Well Name: JUNE JOY Well Location: T24N / R10W / SEC 25 / County or Parish/State: SAN

Sundry ID: 2864788

Type of Action: Plug and Abandonment

CONDITIONS OF APPROVAL

Planned P & A Wellbore Schematic

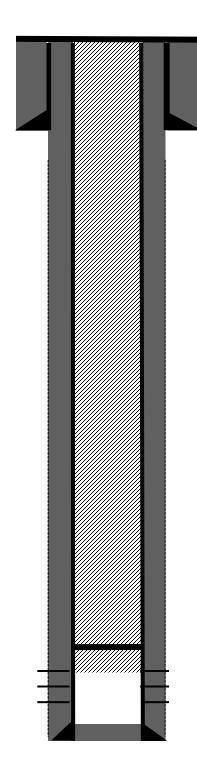
- 1. Plugging operations authorized are subject to the attached "General Requirements for Permanent Abandonment of Wells on Federal and Indian Lease."
- 2. The following modifications to your plugging program are to be made: a. Complete wellbore fill up proposal. No changes to procedure.
- 3. <u>Notification:</u> Farmington Office is to be notified at least 24 hours before the plugging operations commence at (505) 564 7750.

You are also required to place cement excesses per 4.2 and 4.4 of the attached General Requirements.
